LERA

Re: Response to Letter Requesting Additional Information from the Millennium Tower Homeowners Association

As requested in your August 23, 2018 letter to Mr. Vision Winter, we are providing you with additional clarification regarding the basis of our opinion about the safety of the existing building foundation for the Millennium Tower at 301 Mission Street on behalf of the Millennium Tower Association. For clarity, we've repeated your questions in bold and followed with our answers.

Figure 1. 3 Year Look Ahead Based on Recent Settlement Trends – Mat Displacement from Theoretical Elevation

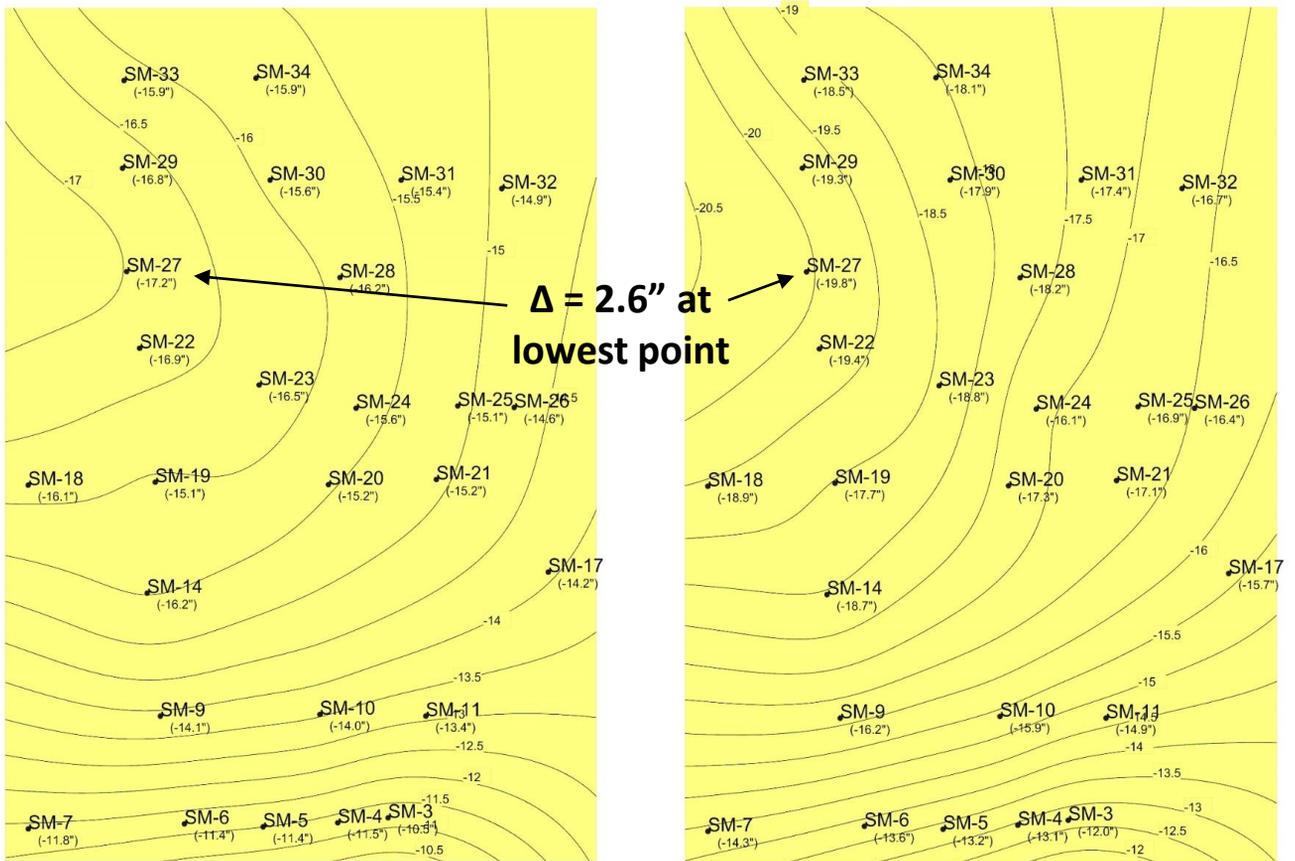
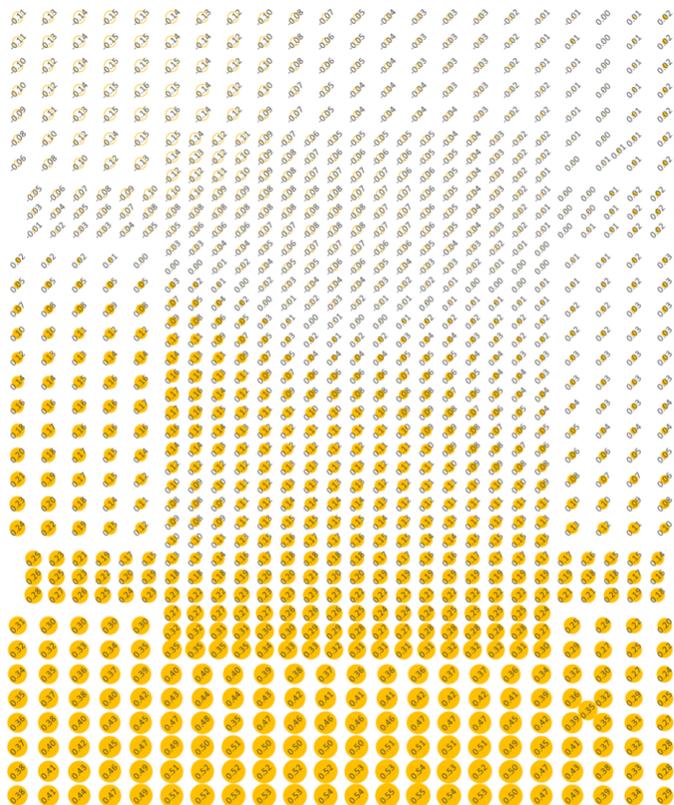
1. ***Pile Stiffness and Settlement Analysis (Figures 13/14 and related text): Please confirm the definition and basis of "long term" as related to the pile stiffness term KOLD BAY CLAY.***
 - a. **Is the stiffness based on the expected settlement three years into the future (i.e. the expected time for completing a foundation retrofit as stated on Page 2) or the present state? How much additional settlement is predicted over the next three years?**

The predicted additional settlement over the next three years is calculated by measuring the change between the first reading on 1/30/17 and the reading on 04/12/18 (437 days) – and then assuming each survey point continues to settle at the same observed rate for the next 3 years (1612 days) to 6/30/2021. See attached Figures 1 to 4 for the three-year settlement forecast and resulting change in pile head rotations.

Figure 2. Initial Pile Head Rotations – (April 12, 2018)

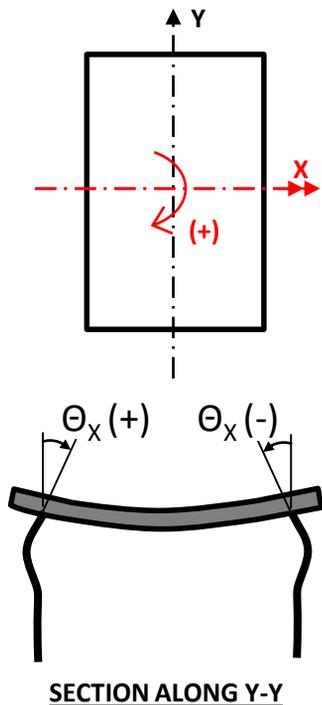
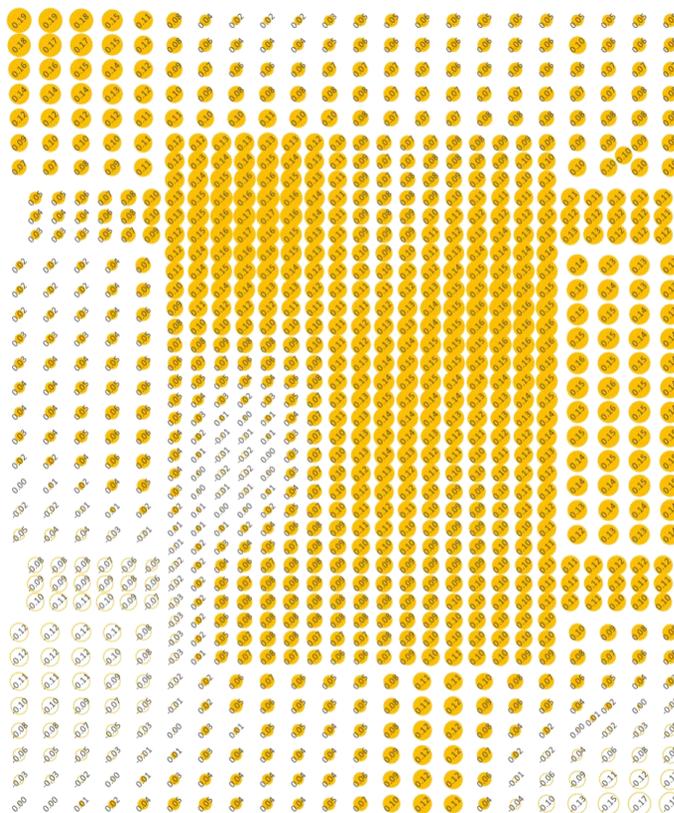
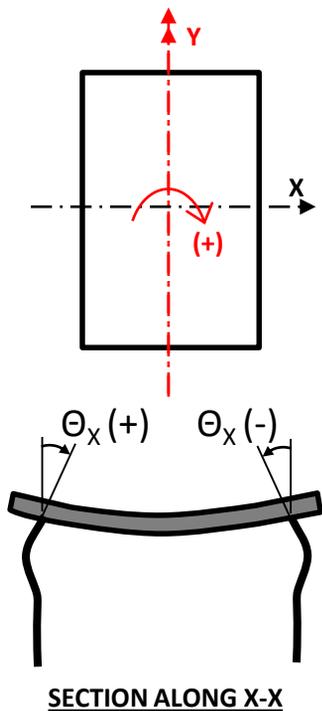
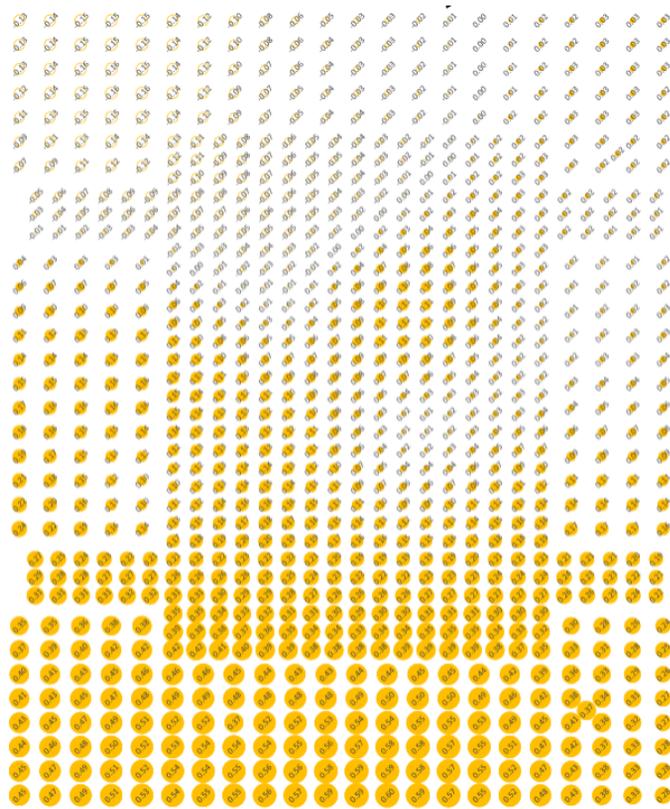
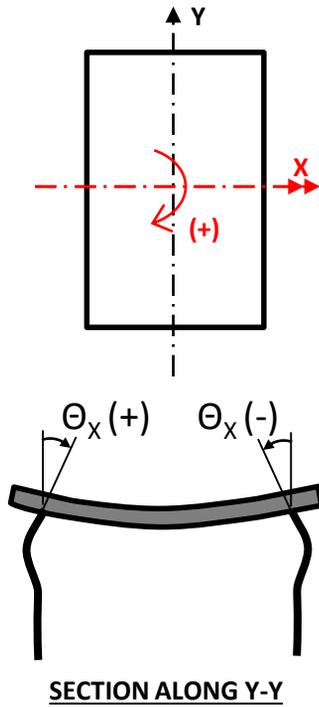
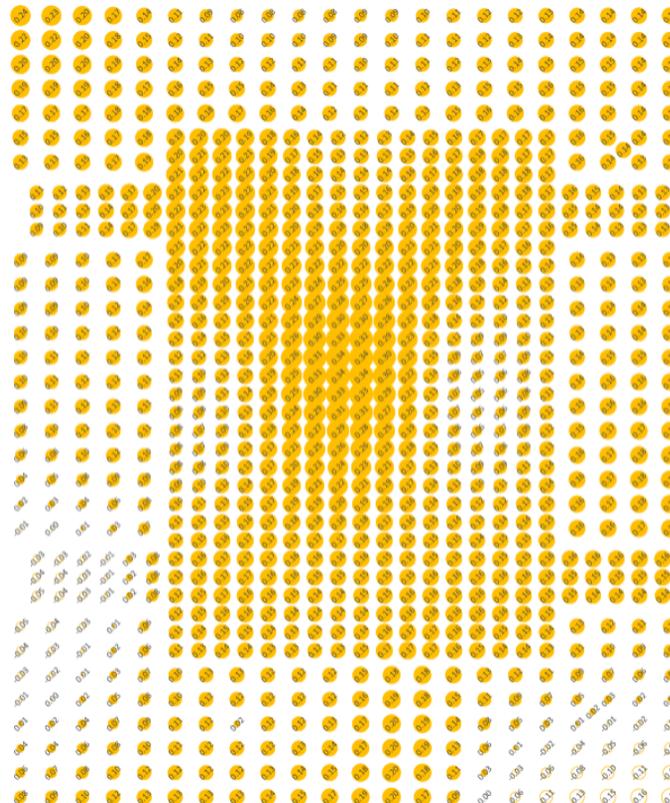
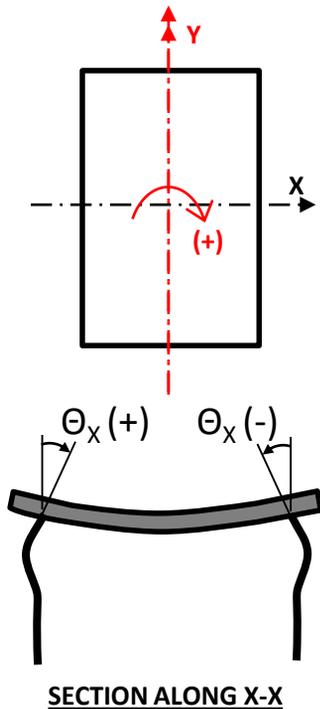
- d. Explain why when pushing south, the first pile yield occurs at zero displacement.**

A 0.5 degree rotation at the top of an existing pile causes yielding in the pile reinforcement just from the rotation. Since the non-uniform settlement and tilting has already caused a few of the piles in the south direction to experience 0.5 degrees of rotation these piles are presently in a yielded state prior to the start of any seismic activity. Refer to Figures 2 & 3 for a mapping of pile head rotations.

Figure 6. Site Plan and Cross Section Through Strata to Bedrock

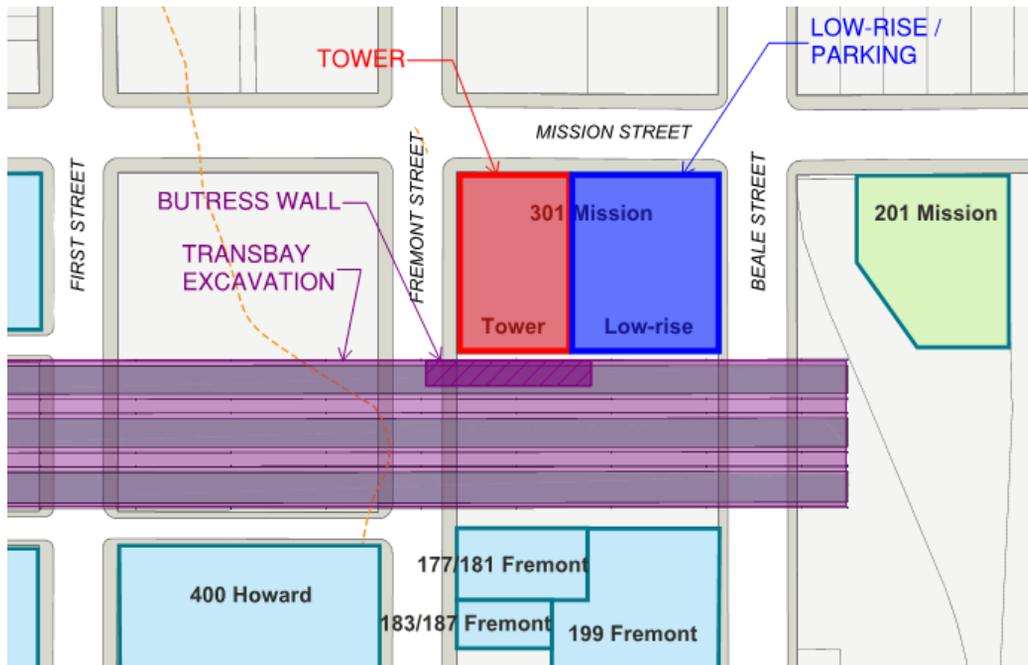
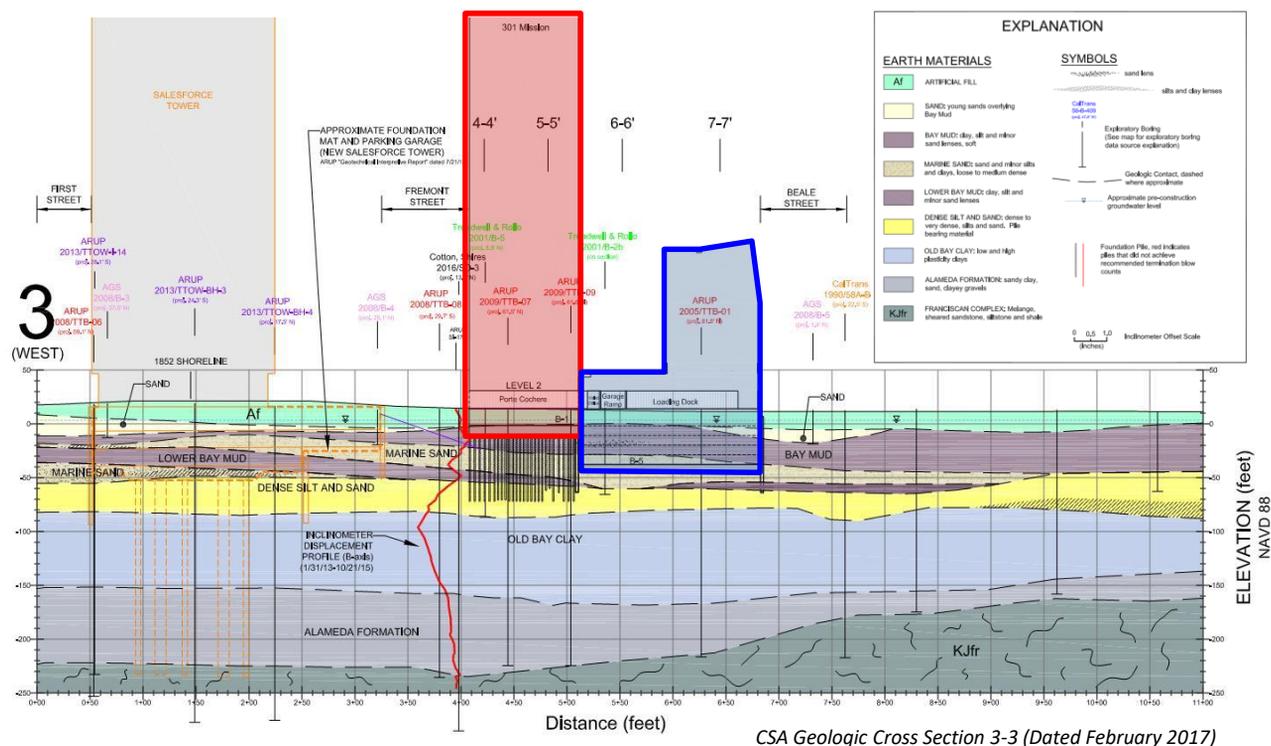
c. Confirm how the pile properties have been calculated (and differentiated across the building site) to result in calculated gravity load settlement displacements in the ETABS analysis.

- E = the long-term static stiffness of the soil, taken as 10 ksi (median value for hard clay, per Bowles T2-8);
- A = area of soil tributary to a pile; and
- L = soil column height, calculated as the distance from the base of the pile tip to the top of the bedrock (see Figures 6 & 7)

Figure 11. Material Models Used in XTRACT Pile Sectional Analysis

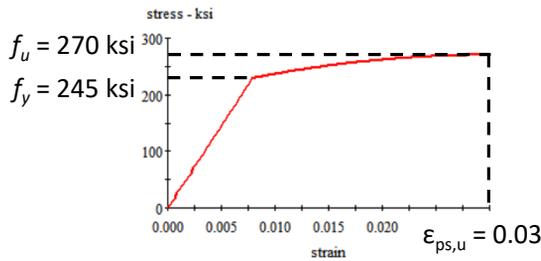
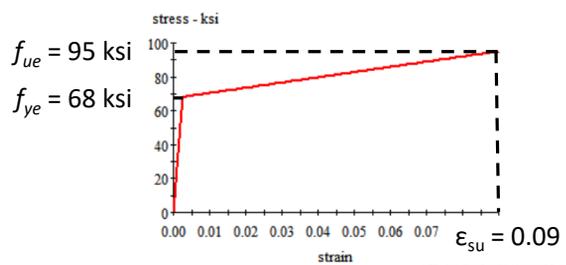
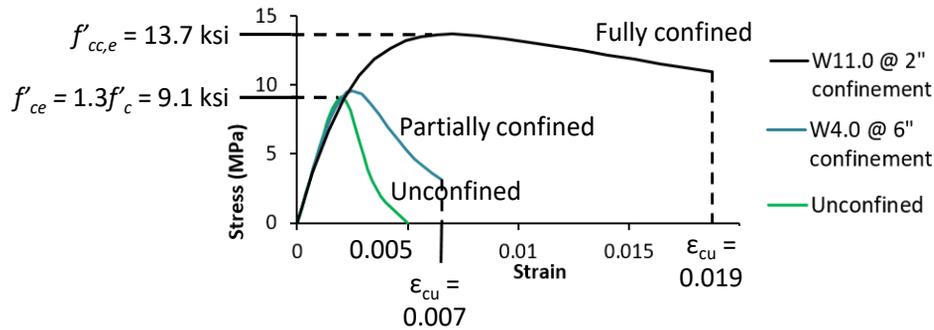
b. Explain the underlying mechanisms that result in the strain hardening behavior in these curves. Is there any available experimental data in the published literature to substantiate this type of strain hardening behavior out to large deflections?

The strain hardening observed in the pile lateral load-deflection curves is due to the strain hardening characteristics of the materials that comprise the piles. These material properties are illustrated in Figure 11, which includes their references. These material behaviors are well understood and well documented.

Figure 12. Pile Hinging Mechanism – Case 1

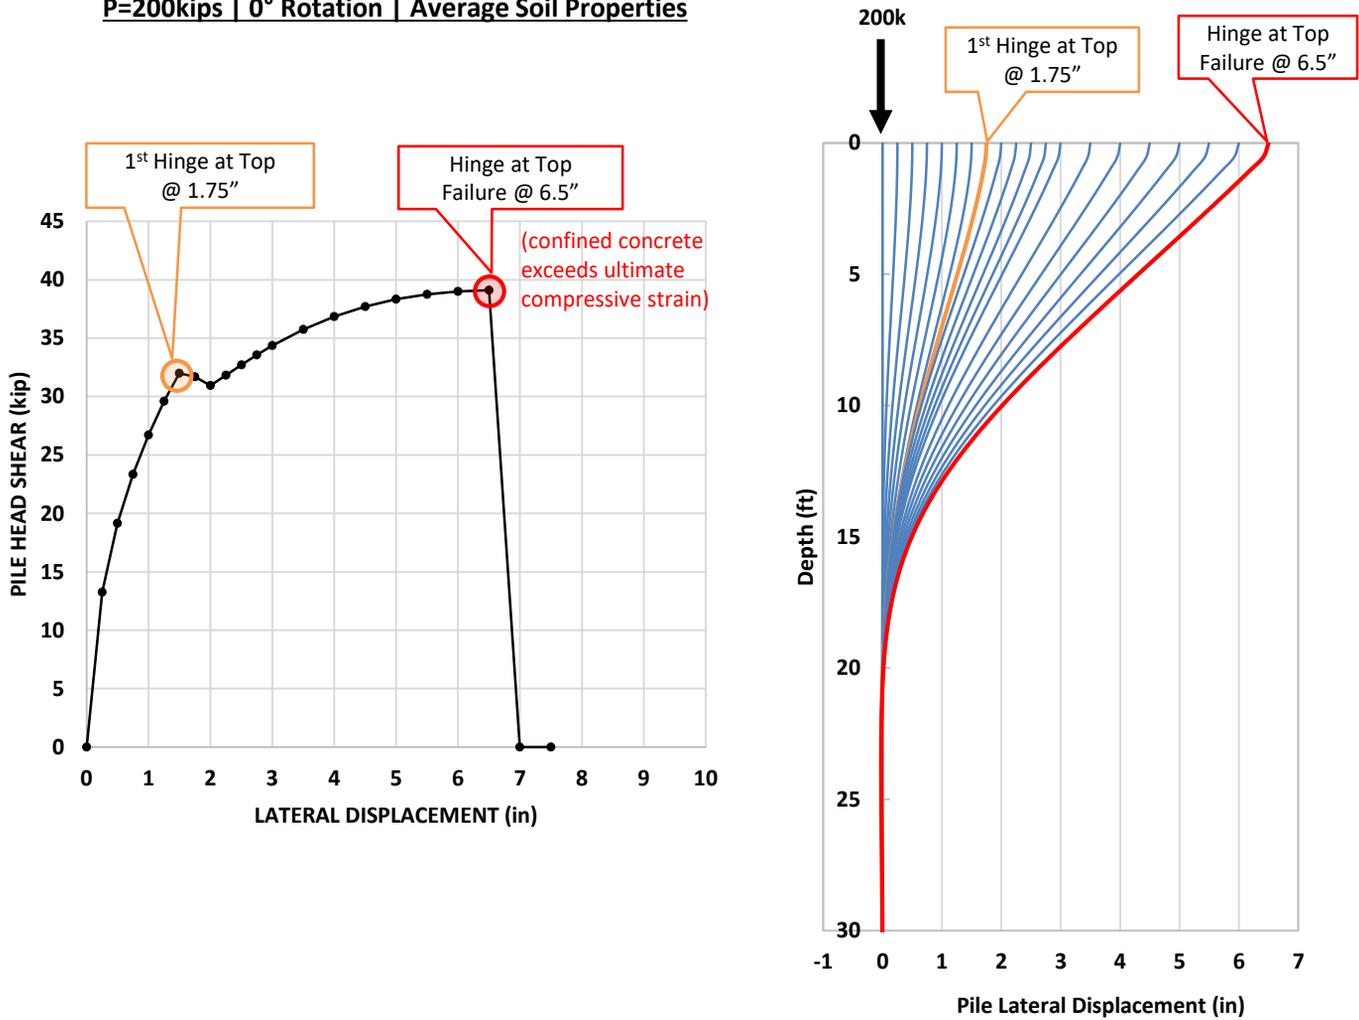
c. Provide a diagram of the deformed shape of a representative pile as it undergoes lateral deflection, including the locations of hinge formation.

- i. Case 1: A hinge forms at the pile connection to the mat. This hinge then fails prior to the formation of the second hinge. See Figure 12.
- ii. Case 2: A hinge forms at the pile connection to the mat. Then, a second hinge forms at some distance below the top of pile prior to the top hinge failure. See Figure 13.

Figure 14. Typical Existing Pile Moment Curvature

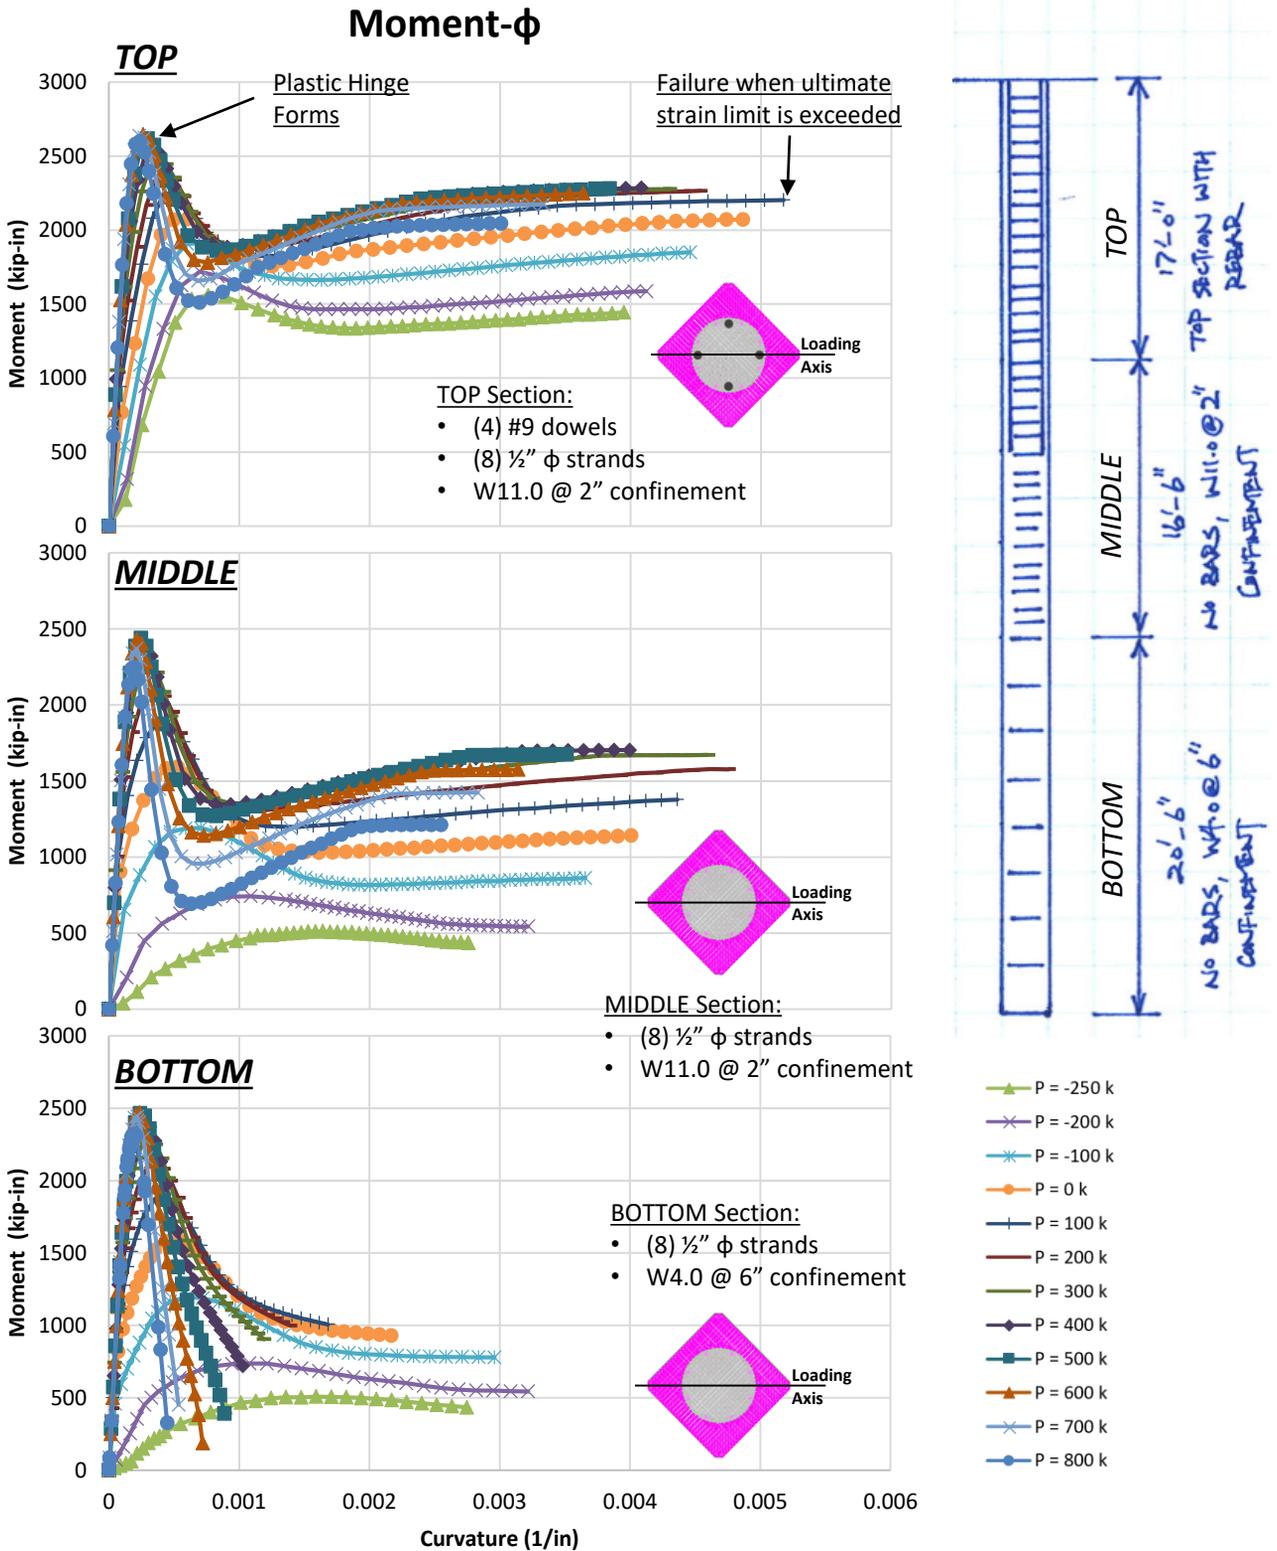
- d. Confirm the reinforcing bar layout that is assumed in the pile analyses at the hinge locations.**

See Figure 14.
